CITY OF GAINESVILLE

Engineering Design & Construction Manual Memorandum 24-02

To: Development Review Team and Community Partners
From: Gail L. Mowry, P.E., City Engineer *Gail Mowry*
Date: October 18, 2024
Re: EDCM 2022 Edition Revisions – Detectable Warnings, Directional Indicators, Driveway Aprons and Sign Lettering, Pipe Material

Downtown and Historic Districts

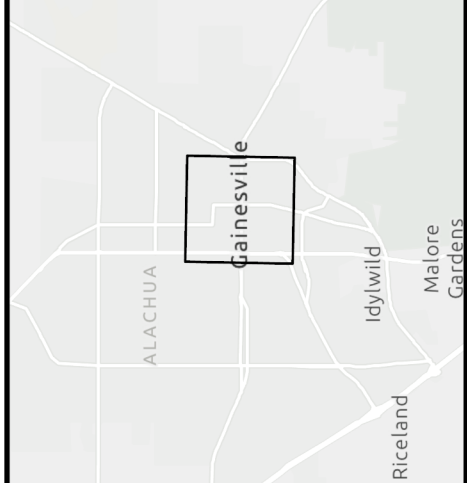
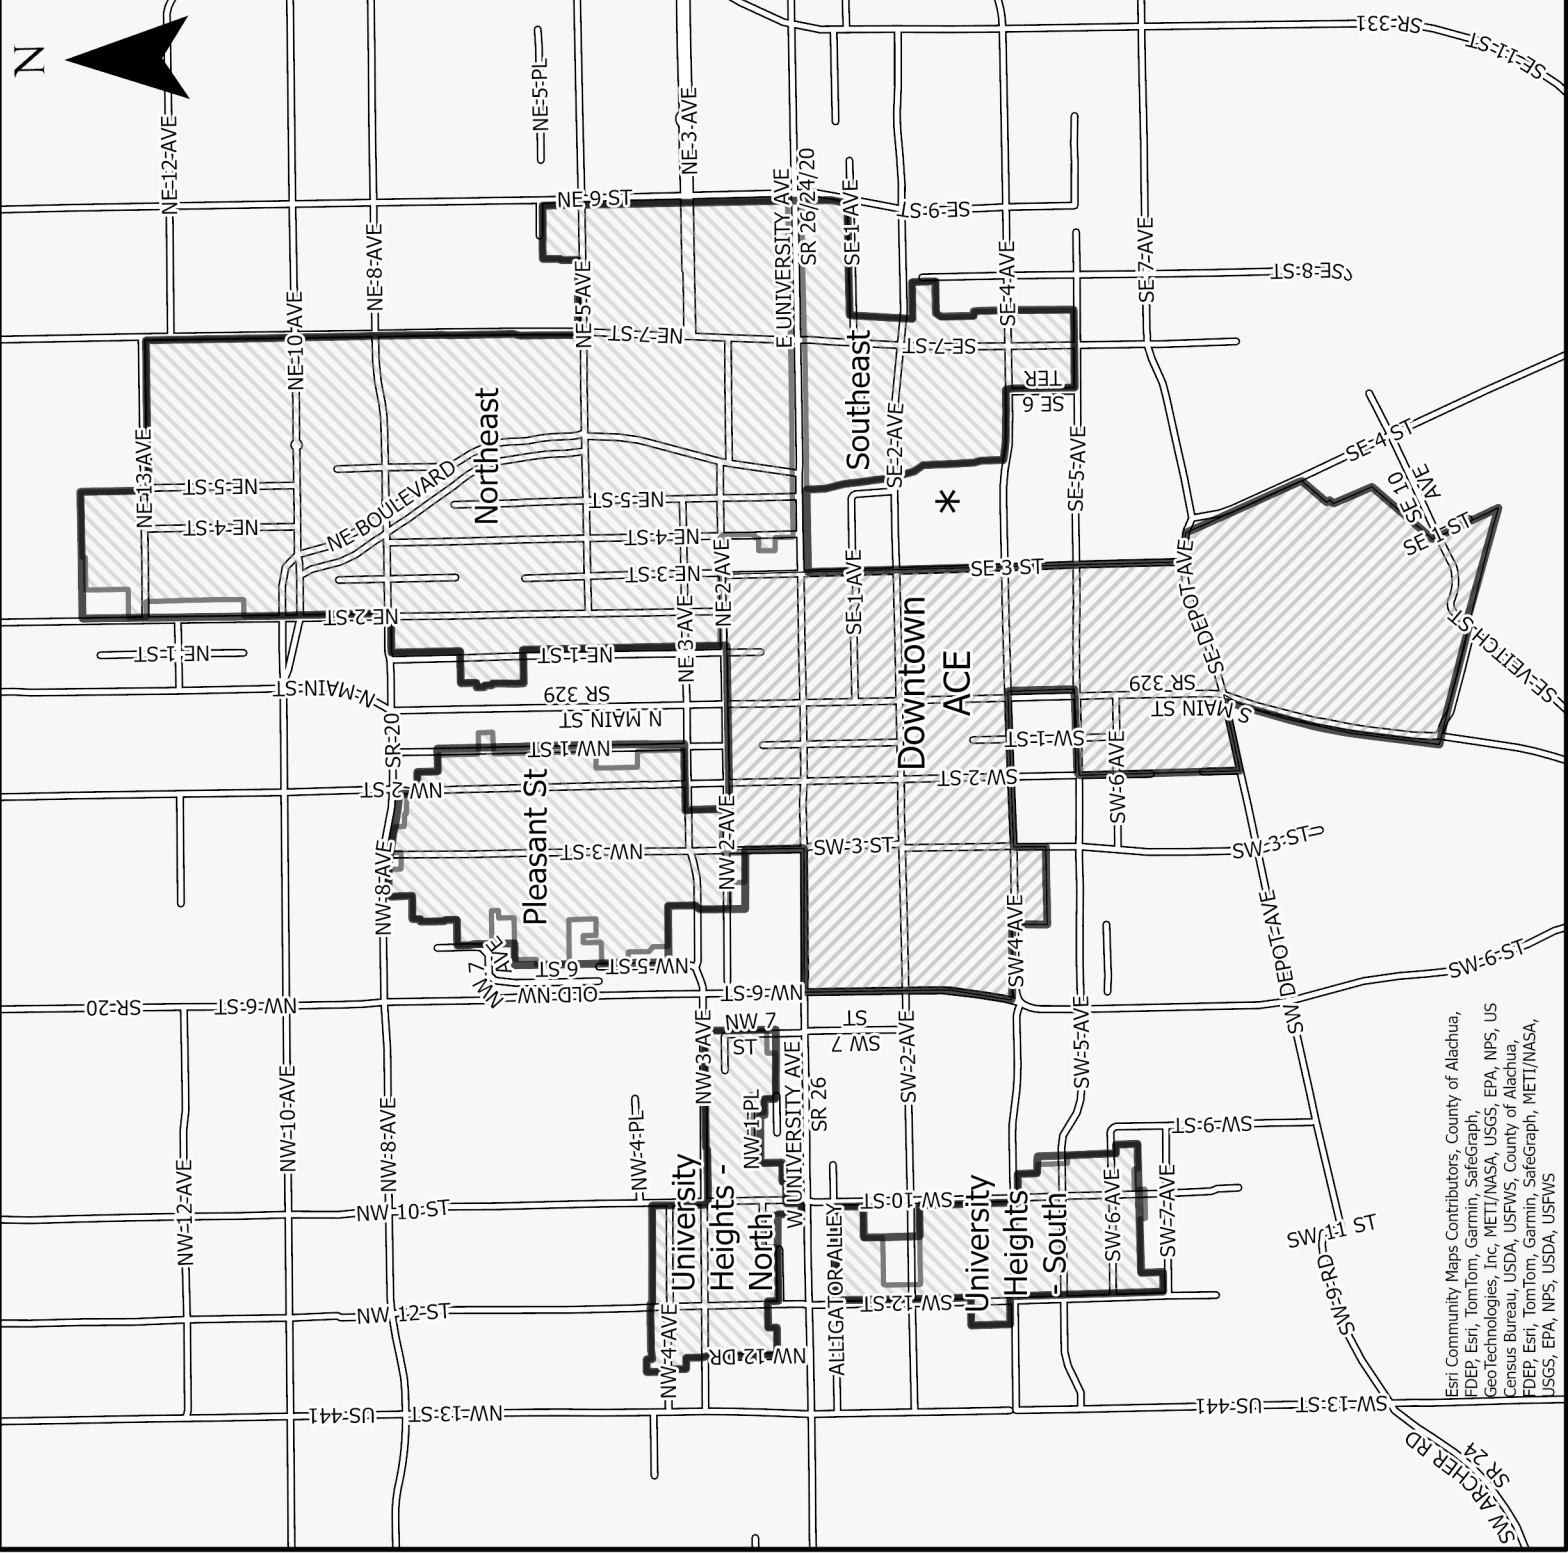
- a. Location shall not be within the Downtown and Historic Districts shown on the attached map. Pedestrian facilities on both sides of roadways bordering these areas shall be considered within the boundaries. Brick may be mandated for specific projects or installations, at the discretion of the City Engineer regardless of location.

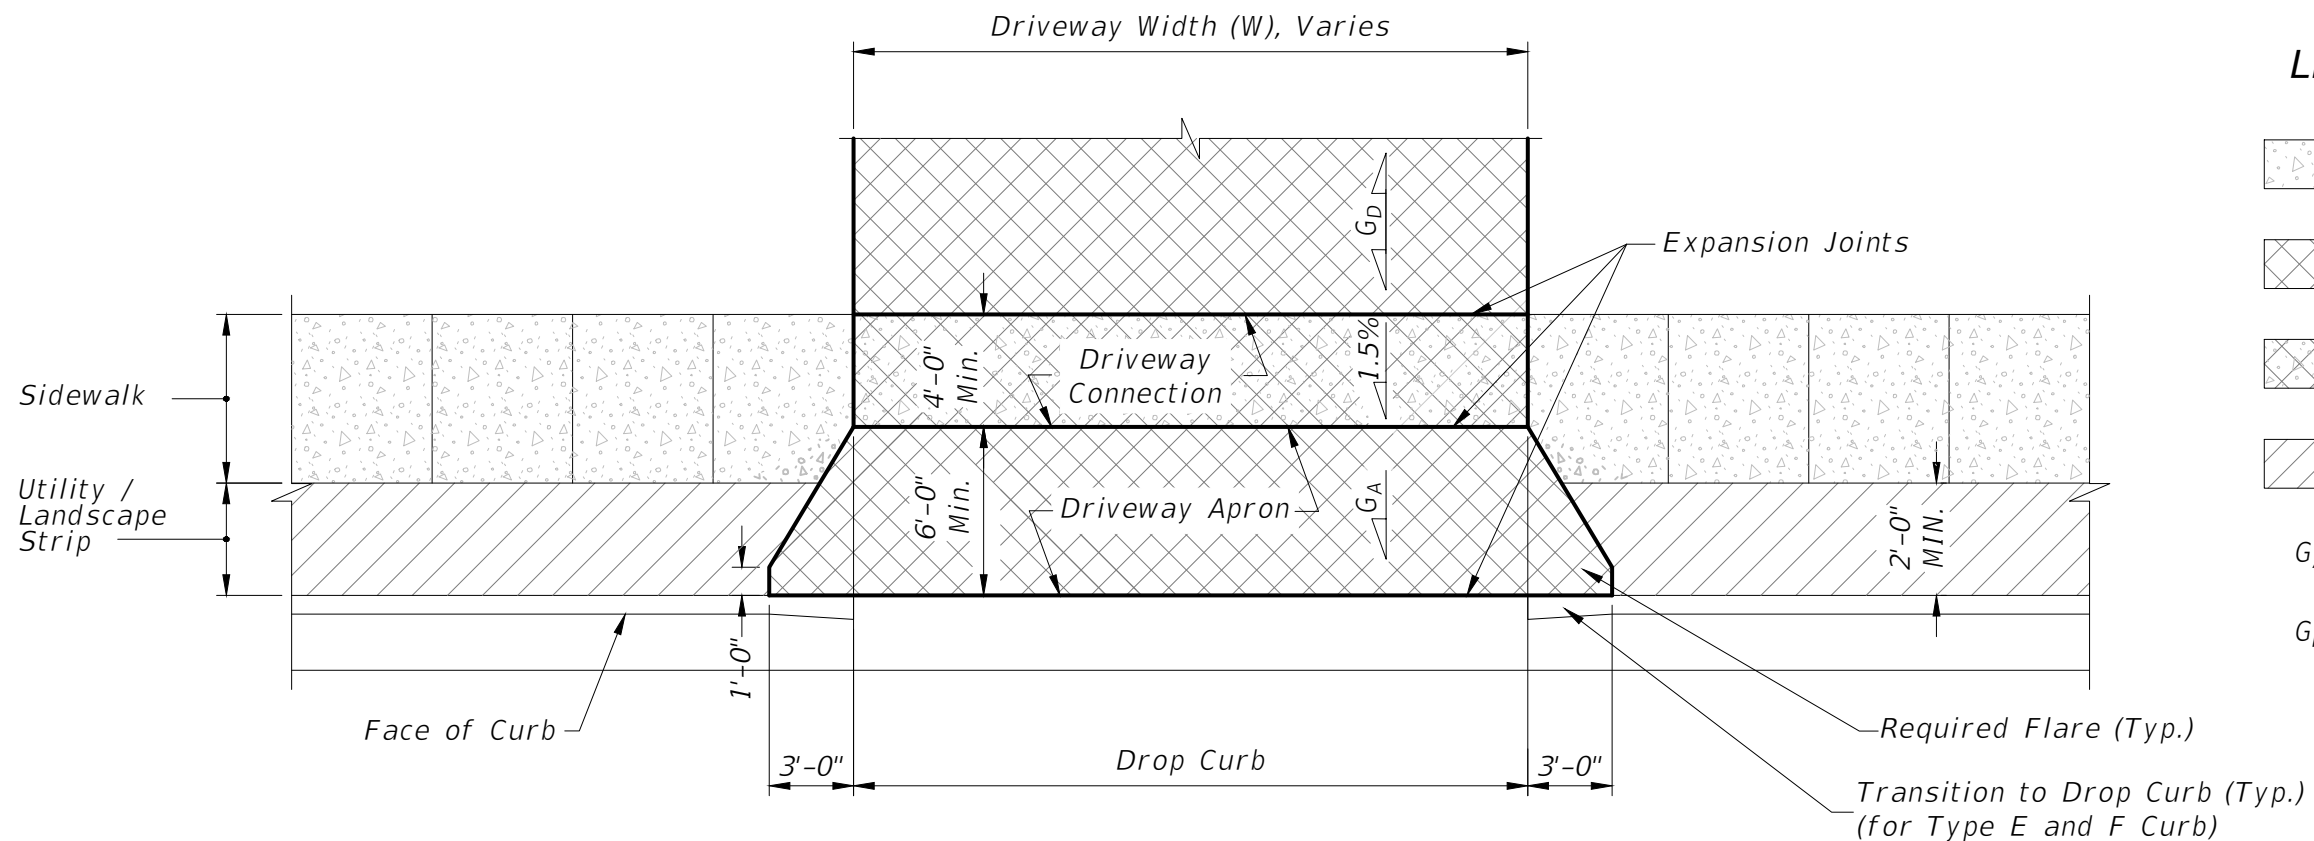
3. The attached detail (Appendix B-10) for concrete flared driveways will be allowed instead of FDOT Standard Index 522-003 only for single family dwellings on minor local streets in residential districts (maximum 800 Average Daily Traffic and posted speed limit 30 miles per hour or less).
